39T-08502/Z-7489/OZ-7510
A. MacLean

TO:	CHAIR AND MEMBERS BUILT AND NATURAL ENVIRONMENT COMMITTEE
FROM:	D.N. STANLAKE DIRECTOR, DEVELOPMENT PLANNING AND DAVID AILLES MANAGING DIRECTOR DEVELOPMENT APPROVALS BUSINESS UNIT
SUBJECT:	APPLICATION BY: KENMORE HOMES (LONDON) INC. 255 SOUTH CARRIAGE ROAD & 1331 HYDE PARK ROAD MEETING ON SEPTEMBER 12, 2011 AT 5:25 PM

TO:	CHAIR AND MEMBERS BUILT AND NATURAL ENVIRONMENT COMMITTEE
FROM:	D.N. STANLAKE DIRECTOR, DEVELOPMENT PLANNING AND DAVID AILLES MANAGING DIRECTOR DEVELOPMENT APPROVALS BUSINESS UNIT
SUBJECT:	APPLICATION BY: KENMORE HOMES (LONDON) INC. 255 SOUTH CARRIAGE ROAD & 1331 HYDE PARK ROAD PUBLIC PARTICIPATION MEETING ON JANUARY 31, 2011 AT 5:00 PM

Kenmore's Proposed Street Pattern

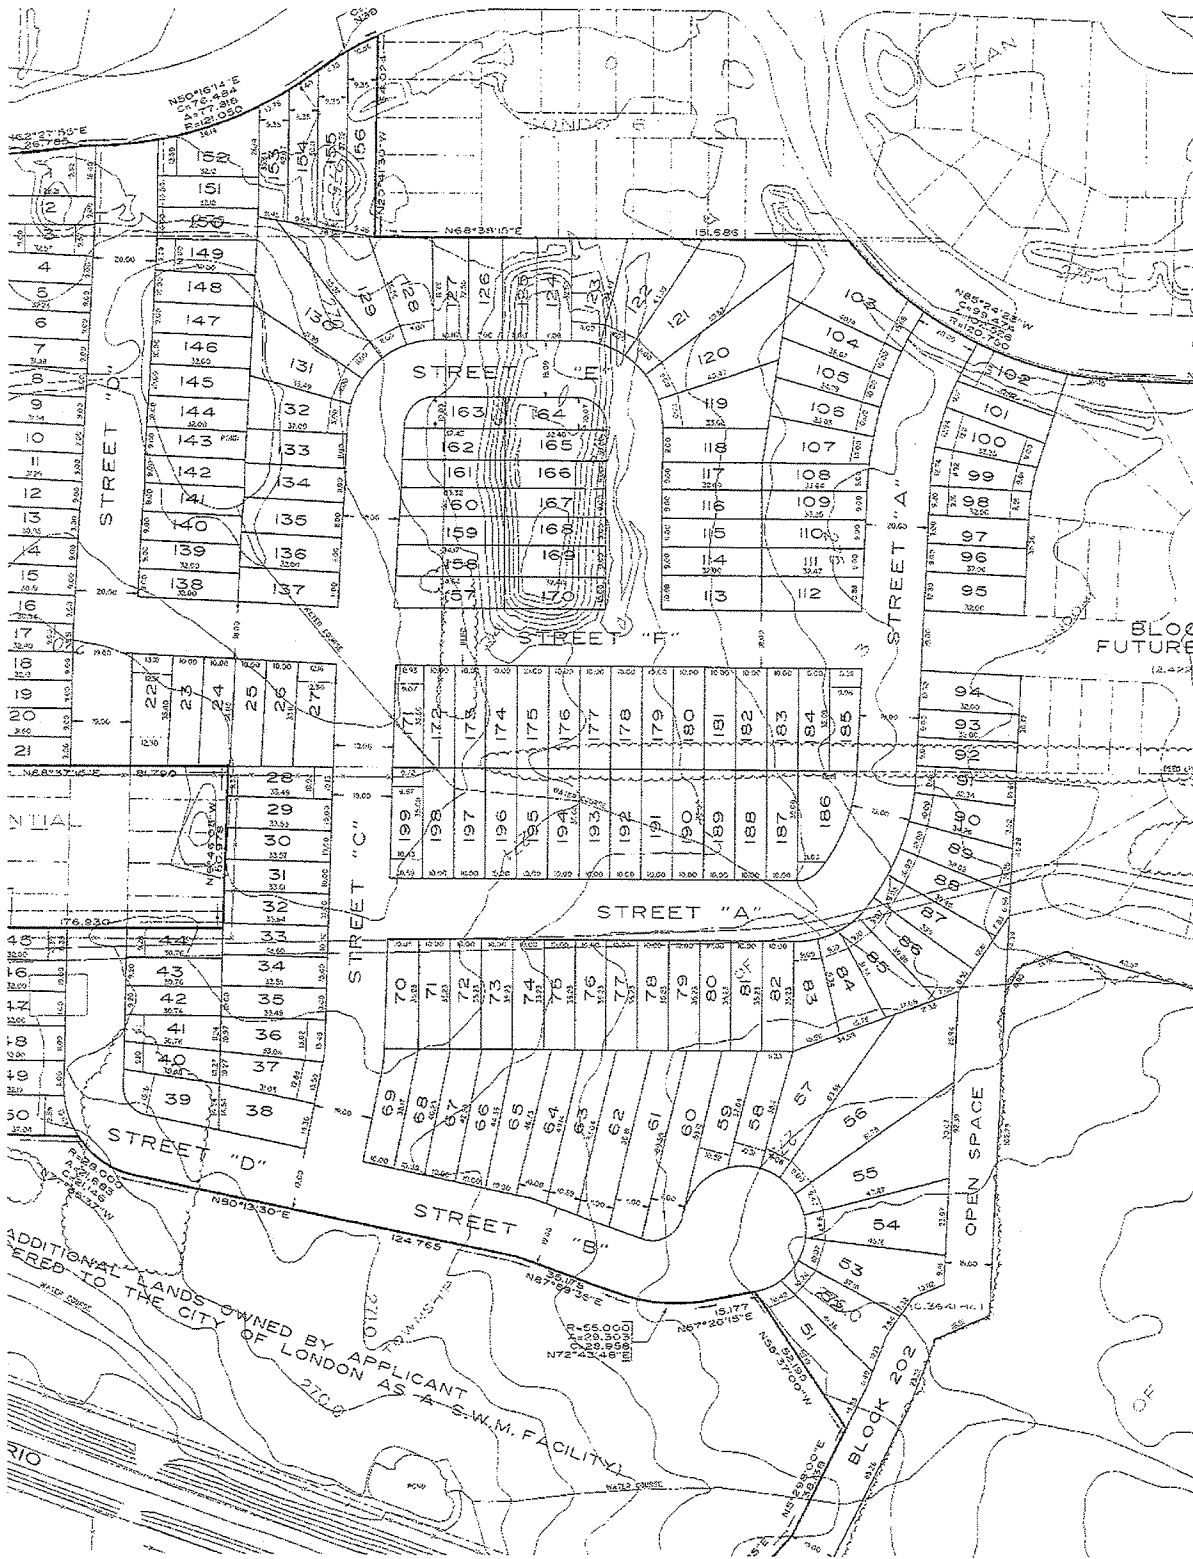
Development Planning staff noted in their January 31st report to BNEC that a redesign to the internal road pattern should be considered in order to provide for an overall improved vehicular and pedestrian circulation for the subdivision and the area. Staff recommended that the draft plan be redlined so that the easterly limit of Street B be connected to Street A. It is staff's position that this will provide for better vehicular and pedestrian circulation and in the long term it will provide for a continuous street from Coronation Drive to South Carriage Road. It should also be noted that staffs redline amendment is based on the original road pattern submitted by the applicant in 2008.

Mr Knutson noted in both his May 16th and June 14th correspondence that for reasons relating to marketability, livability and value, the original Kenmore plan is their preferred plan noting that there is no City policy directing any particular street pattern. They also note that their original design results in a shorter road length by approximately 82 metres which represents greater value with its enhanced privacy and reduced traffic. Conversely, staff note that an increase of 82 metres of street length would provide for an increase of saleable lot frontage which could result in greater returns for the owner.

EESD Transportation staff have reviewed both designs and they have concluded that the subdivision design proposed by Development Planning will not generate any noticeable increase in traffic volume or create higher speeds than the applicants' proposal. It is their opinion that with the City's revised street pattern traffic volume will be more evenly spread between the local streets because the loop design provides more access to the southerly part of the subdivision. The greatest impact will be on Street 'C' which, until Street 'D' is extended through the remnant parcel, is the only access to the southerly part of the subdivision proposed by the applicant.

It is staffs' position that should the applicant wish to proceed with a revised land use designation over a larger area this should be addressed through a new application to amend the Official Plan. As noted in our January 31, 2011 report Development Planning staff have no information to support the notion that varying lot sizes and housing types have a negative impact on adjacent property values. In this instance the applicant has proposed a variety of lot sizes to provide for more choice in housing and staff do not support the request by area residents to increase the frontage of lots along the northern limit of the plan. Development Planning staff do not support the applicants original street layout noting that the proposed redesign will improve

Proposed Street Pattern

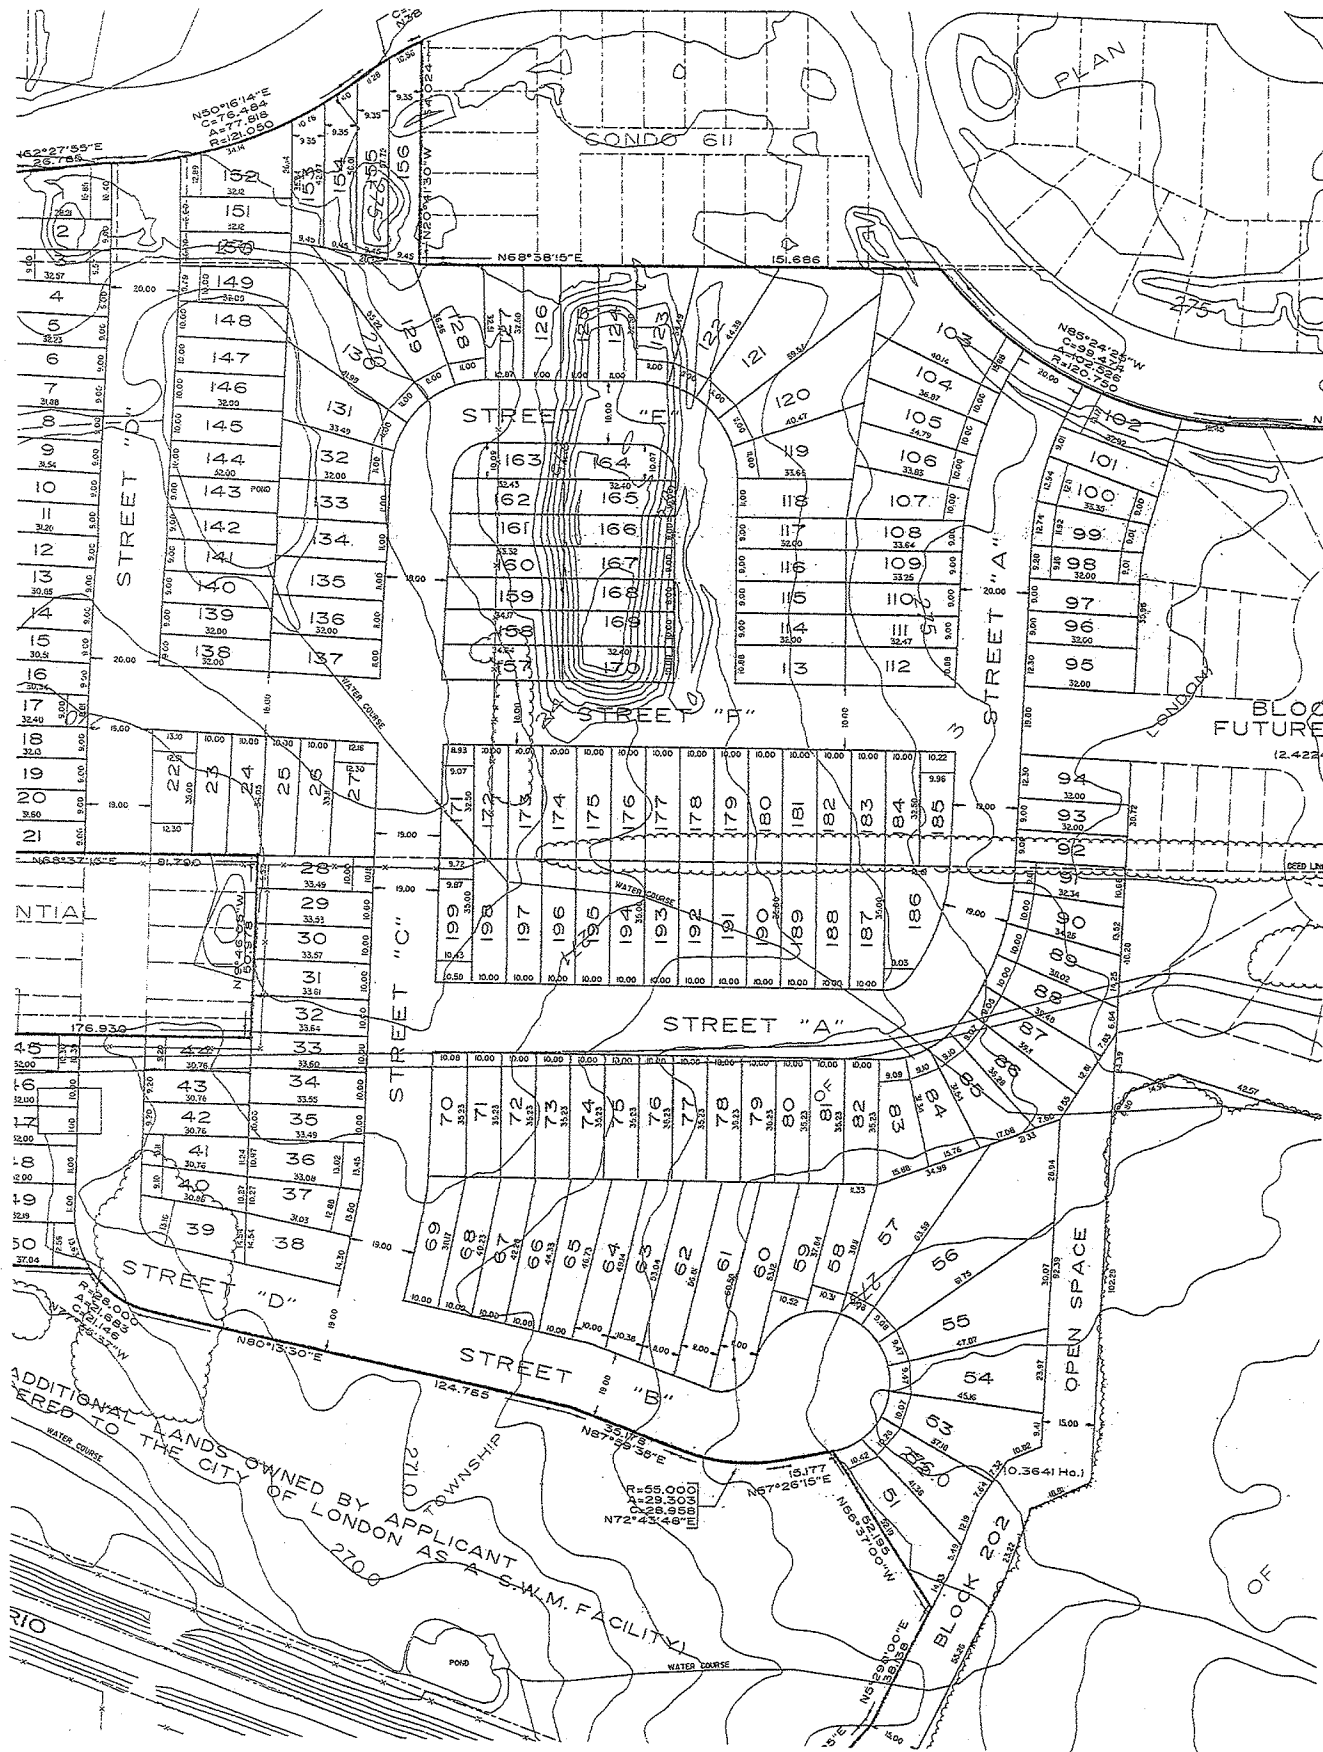
3. The proposed redline amendments will provide for:
 - a. Better pedestrian linkages within the plan and neighbourhood;
 - b. Improved access to future development blocks from internal streets which in turn reduces conflicts relating to access from the arterial road; and

Redline Revised Plan

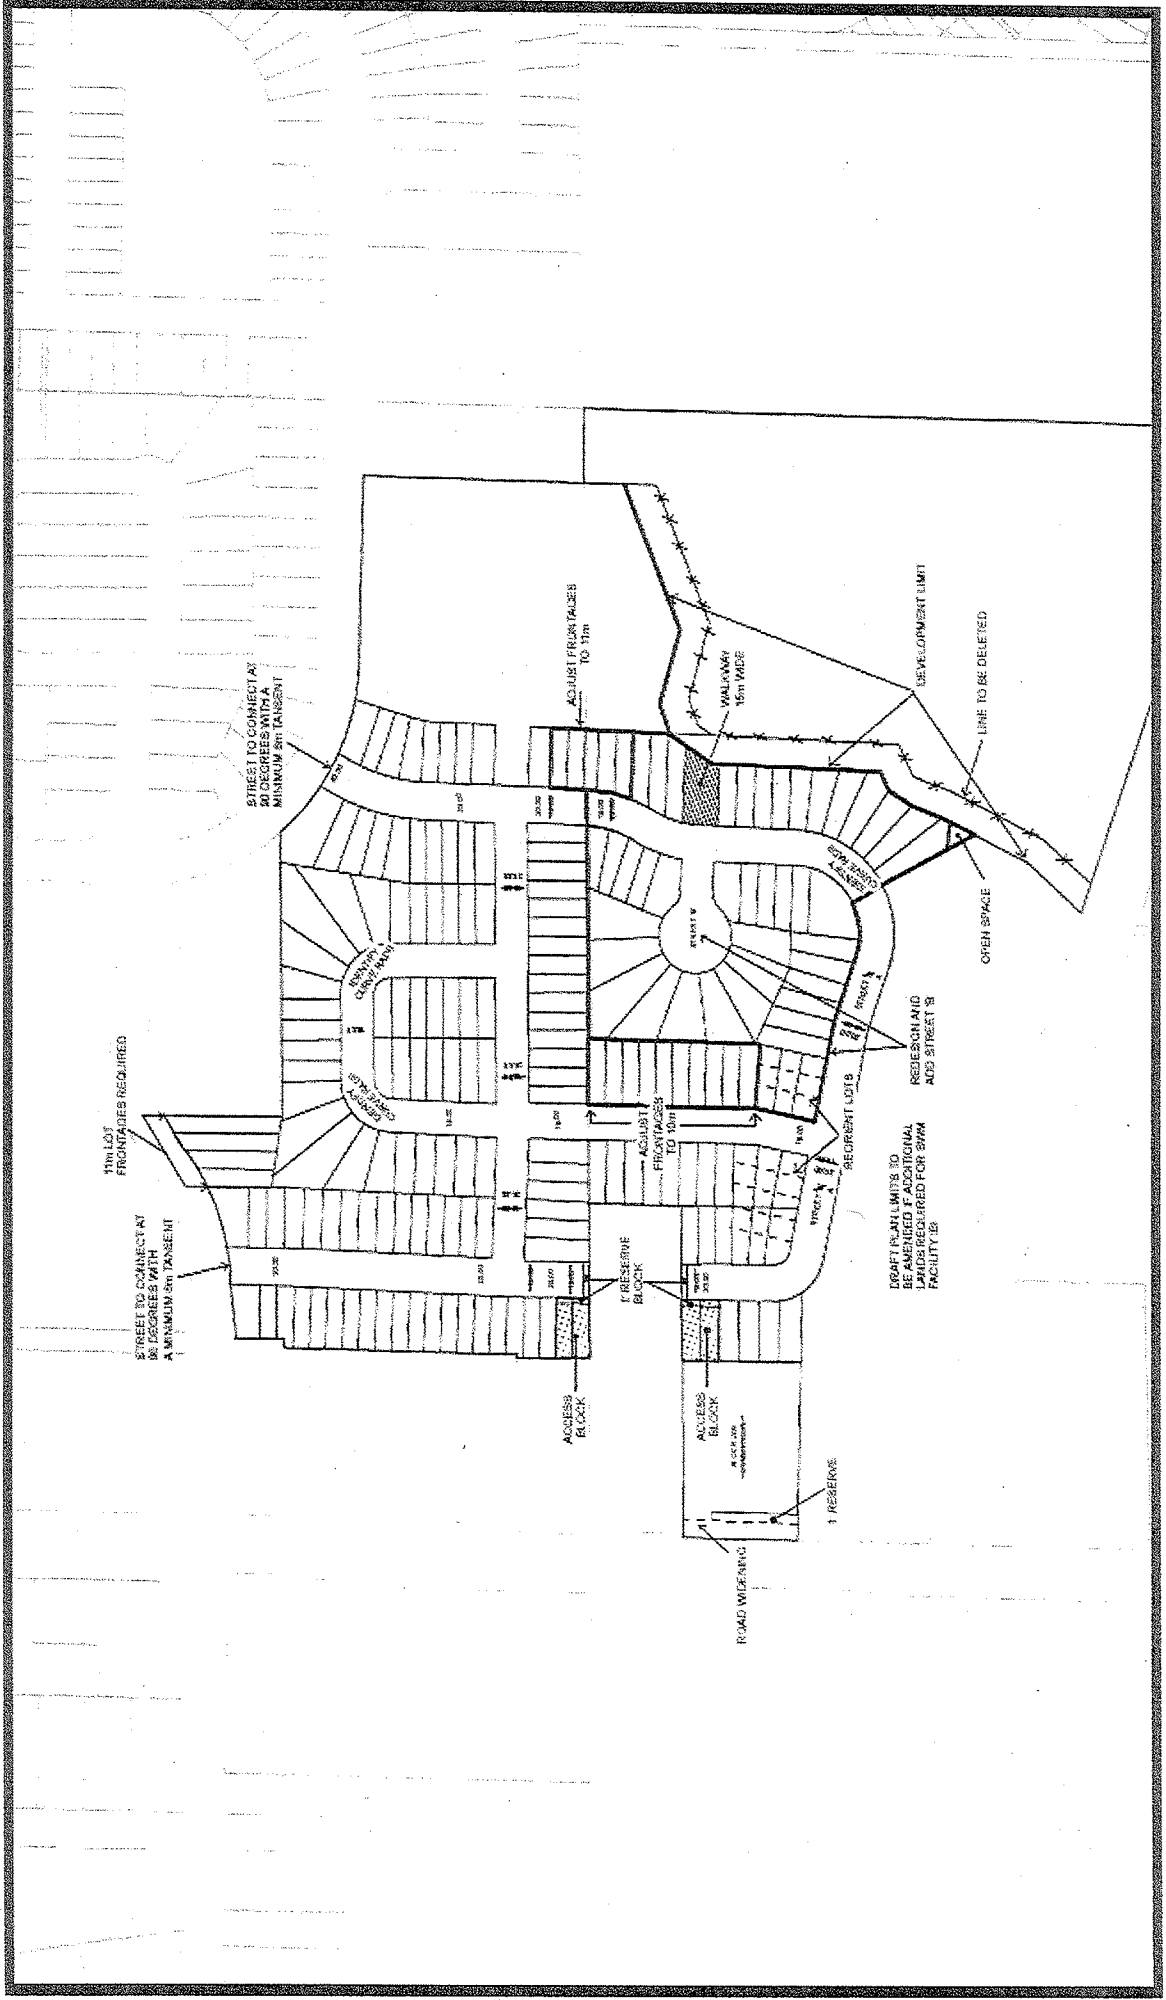
Lots 20, 21, 45 and 46 have been redlined on the plan as blocks to allow for future access to lands to the west. Also, prior to the lands to the west coming forward for development, these blocks should be of sufficient size to accommodate snow storage at the terminus of Street "A" and Street "D" until such time as these streets are extended through the property located at 1351-1357 Hyde Park Road.

Staff Response: As per EESD's request, it is recommended that access from Street "D" to future multi-family lands to the west be provided. It is Development Planning staffs opinion that identifying one (1) lot for access is insufficient as this frontage is too restrictive. The access width should be widened to ensure that development has adequate room to allow for driveways and sidewalks in a safe location. In addition, community mailboxes, visitor parking, and entrance features are often found near the front of multi-family developments. In this instance, a minimum frontage of 18 metres (i.e. two lots) is considered satisfactory to maintain maximum flexibility regarding the location of the driveway and sidewalk. Widening the frontage would also allow a public road to be constructed should such freehold development be desired for this tract of land in the future.

Therefore it is recommended that lots 20 and 21 be consolidated as a block (shown as Block A on the redline amended plan) to allow for future access to abutting lands. It is also recommended that this block be zoned Urban Reserve (UR3 - similar to abutting lands to the west) and that a holding provision be applied to ensure that these lands are developed in conjunction with abutting lands (h-108). Development Planning staff are similarly recommending that this also be applied to lots 45 and 46 to allow for access to that multi-family residential block to the west.

Recommendation 1 and 1a: An addendum to the EIS was provided by Earthtech which included a final development plan that clearly identified all lots and blocks and the location of the 15 m buffer. This is shown on the redline amended plan.
